Our reference: P-376868-Y2C0
Contact: Kathryn Saunders, Principal Planner
Telephone: (02) 4732 8567

SSD-10272349 – Response to Submissions for Yiribana Logistic Estate

Civil plan no. SSDA432 indicates that Estate Basin 2, which is a combined OSD and bio basin is located in the corridor. DPE is to ensure that the corridor is for 'riparian' purposes and not OSD and trunk drainage.

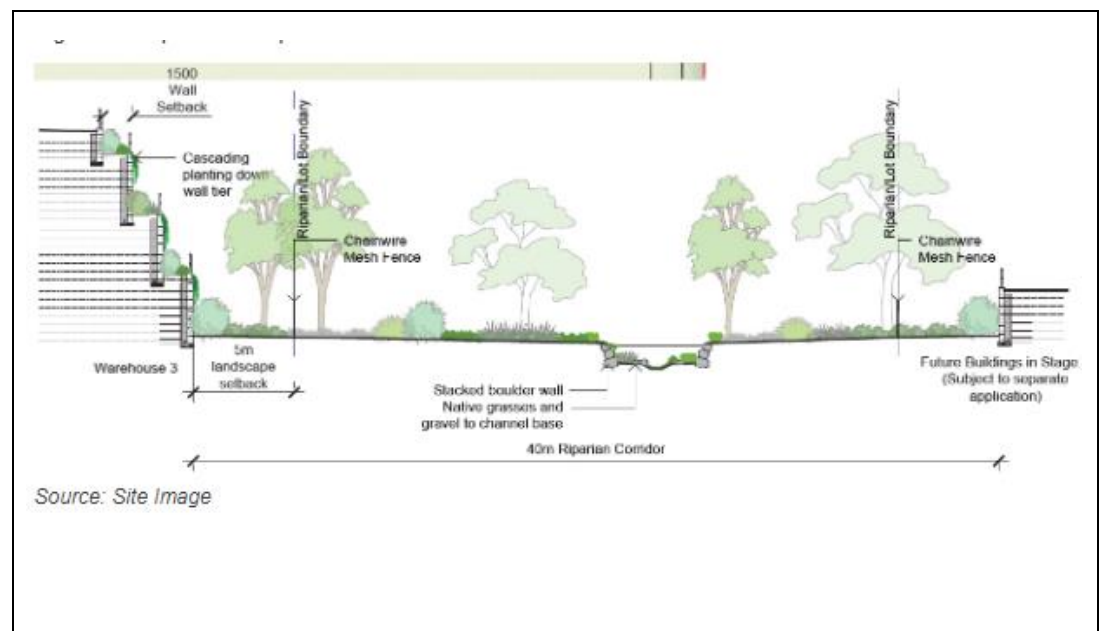
OSD and Bio Basins located within corridor
